City of Rancho Palos Verdes
Rancho Palos Verdes ADA Assessment
Facility Report with Photos

Facility ID: # Area 9 Bus Stops

Location: Western Ave./ Trudie Dr. (SB) Photo # 28

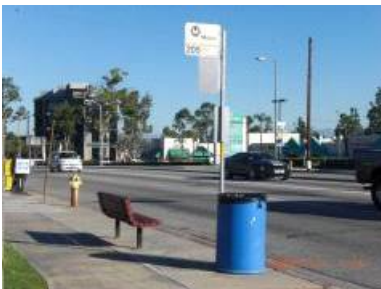
Keynote 30

Field Condition	
02.12B - Bus Stop Pad Slope Perpendicular to Roadway - Bus stop pad slope perpendicular to the roadway exceeds 2%.	1991 ADAAG 10.2.1
Existing Condition: 3.2% CS.	2004 ADAAG 810.2.4
	2007 CBC 1121B.2.1
	Other

Corrective Action
027 - Site Work - Miscellaneous - See Additional Comments
Additional Comments: See Keynote 29 for corrective action.
